APPLICATION NO.	FILING DATE	FIRST NAMED INVENTOR	ATTORNEY DOCKET NO.	CONFIRMATION NO.
10/558,840	12/16/2005	Alexander Zernickel	INA-17	8368

Office Action Summary	Application No. 10/558,840	Applicant(s) ZERNICKEL, ALEXANDER	
	Examiner Greg Binda	Art Unit 3679

FIG. 3

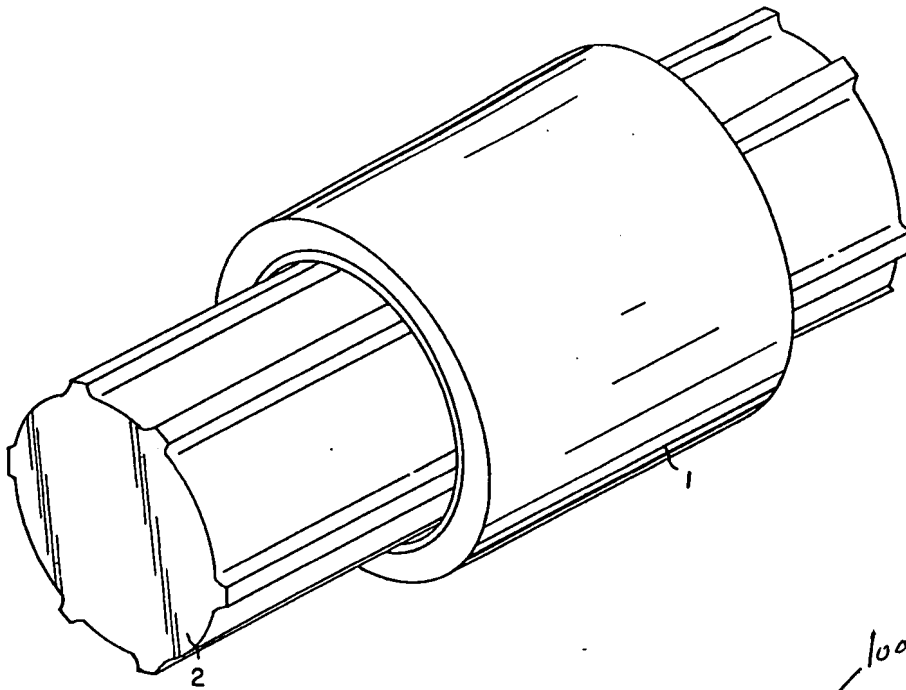
14. Claims 1-19 are rejected under 35 U.S.C. 102(b) as being anticipated by Watanabe, US 4,634,296. Figs. 3-8 show a linear rolling bearing for transmitting torques about its longitudinal axis, having an inner profile element 2 and an outer profile element/hollow body 1 which surrounds the inner profile element at least partially, the two profile elements being mounted via rolling bodies 3 such that they can be displaced with respect to one another in the longitudinal direction, which rolling bodies circulate endlessly in at least one first circulatory channel (see attached annotated drawing) and in at least one second circulatory channel (see attached annotated drawing), the circulatory channel having a loadbearing channel 4b (see attached

annotated drawing) which is parallel to the longitudinal axis, a return channel 4c which is parallel to the longitudinal axis, and two deflection channels 4c which connect the loadbearing channel 4b and the return channel 4a to one another in an endless manner, the rolling bodies which are arranged in the loadbearing channel of the first circulatory channel being provided for transmitting a torque in the **clockwise direction** between the two profile elements, and the rolling bodies (3) which are arranged in the loadbearing channel of the second circulatory channel being provided to transmit a torque in the **counterclockwise direction** between the two profile elements.

Figs. 4 & 7 show the rolling bodies 3 are arranged with play in the return channels 4a and without play in the loadbearing channels 4b.

Watanabe's metal hollow body 1 is not disclosed as being made from any thing other than a typical metal is used for making a hollow shaft. Therefore it, like the instant hollow body 13, can be deformed resiliently (see item 12d above). Since the hollow body 1 in Watanabe can be deformed, the play at a return channel 4a can be reduced so that the return channel carries load.
